**Re: Request advice on the RTS for SSD-58978472 – Kelso Crescent Multi-Level Warehouse, Moorebank**

## Attachment A – Detailed comments

### 1. Urban Design

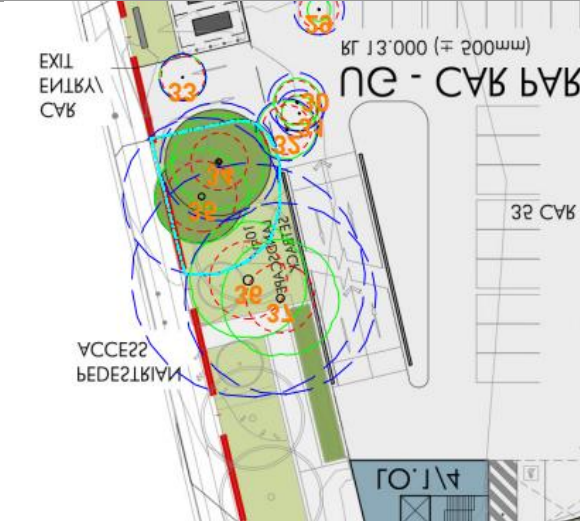
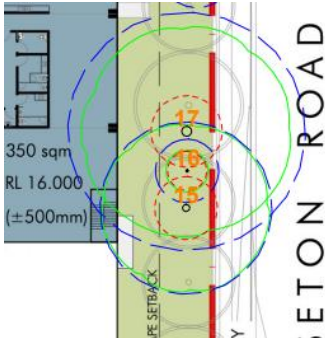
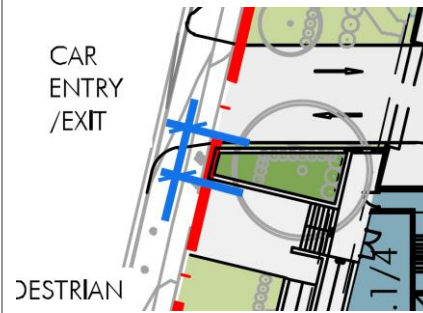
<p><b>Tree Retention</b></p> <p><i>Several native, mature trees in good condition and within the front landscape setback and proposed to be removed (being: T15, T16, T17, T36 and T37), and this is not supported. Pot sizes should therefore be increased for several of the trees to a minimum 100L, and 200L for street trees, to reduce the time it will take for canopy to establish</i></p>	<p><b>Not addressed</b></p> <p>These trees are all native, mature trees, all in at minimum good condition except for T16 which is 'fair' condition.</p> <p>T36 – the pedestrian entry could be reconfigured to keep.</p>

<div data-bbox="815 170 1398 689"></div> <p data-bbox="815 768 1398 831">Unclear why T15, T17 cannot be retained as well, now that T16 is being retained.</p> <div data-bbox="815 853 1141 1189"></div> <p data-bbox="815 1267 1398 1330">The Arborist report just states 'Remove' against these trees with no justification why.</p> <p data-bbox="815 1408 1398 1471">Street trees have not been shown, these should be shown and pot sizes at 200L.</p>
<p data-bbox="193 1552 802 1583"><b>Safety and Amenity</b></p> <p data-bbox="193 1606 802 1944"><i>The Kelso Crescent car park entry is very close to the main pedestrian entry. Council recommends the applicant increases the separation between both entries to improve safety for pedestrians. Council is supportive of the external terrace to the office space, however, seeks clarity as to whether it is accessible to all staff or just those working in the adjacent office. The applicant should demonstrate that all staff</i></p>	<p data-bbox="815 1606 1398 1637">Not addressed.</p> <p data-bbox="815 1715 1398 1778">The car park and entries are not separated by 8m landscaped as described.</p> <p data-bbox="815 1856 1398 1919">The distance/dimension in question is illustrated below and appears to be 2-3m.</p>
